17-122CU - Rockin' Jump Dublin

Request

Review and approval of a conditional use for a recreational and entertainment (indoor) use within the TF, Technology Flex District.

3. Site Plan

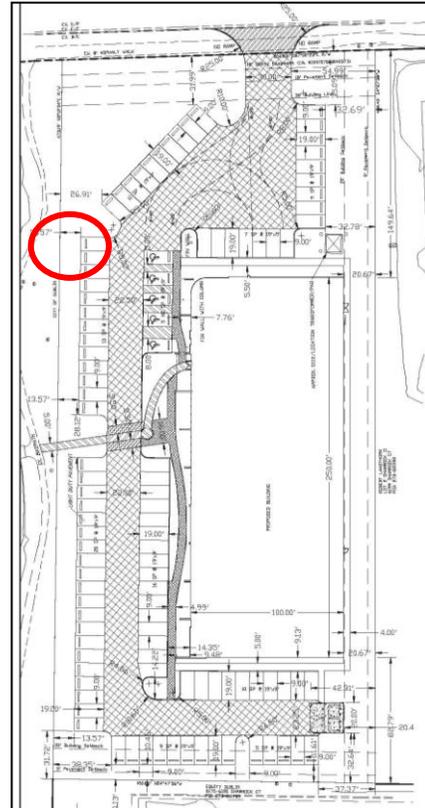
The site layout shows the proposed building located on the eastern side of the lot. Access is off Shier Rings Road and the parking area wraps around the building on all sides with the exception of the east.

A dry detention basin is proposed at the northwest corner of the site for stormwater management.

The building entrance is proposed on the west elevation facing Shier Rings Green Space. A plaza is proposed at the entrance which allows for drop off and provides pedestrian access to the park. The plaza will have a different pavement treatment along with spherical concrete bollards. A dumpster and enclosure is proposed in the southwest corner of the site.
